IEEE P802.11
Wireless Access Method and Physical Layer Specifications

Title: Proposed changes to D1 Section 12 based on Ballot Changes

Abstract: **What's Wrong:**
Some people inexplicably voted against the IR PHY Section with comments.

How To Fix It:
Accept the corrected Section 12 text as shown below

Figure 12-2: PMD Layer Reference Model

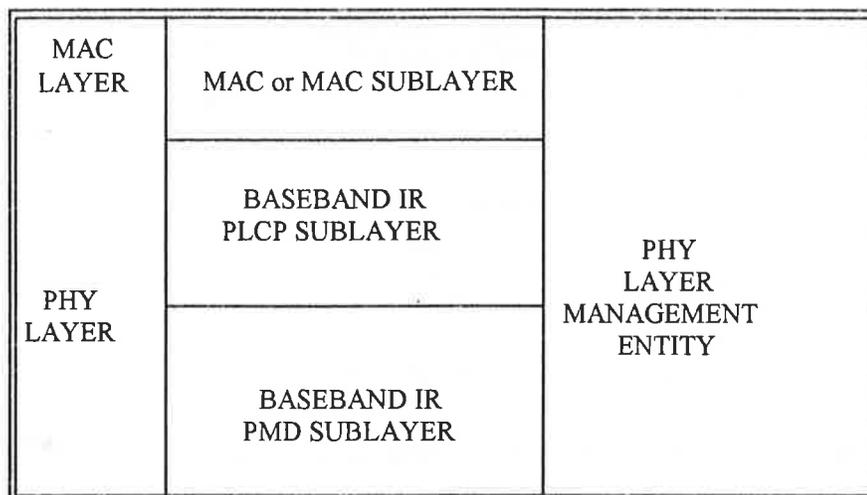
This section describes the PMD functional, electrical, and optical characteristics required for interoperability of implementations conforming to this specification. The relationship of this specification to the entire ~~Baseband~~-IR PHY Layer is shown in figure 2-11 in section 2.9 *Reference Model. 12-2.*
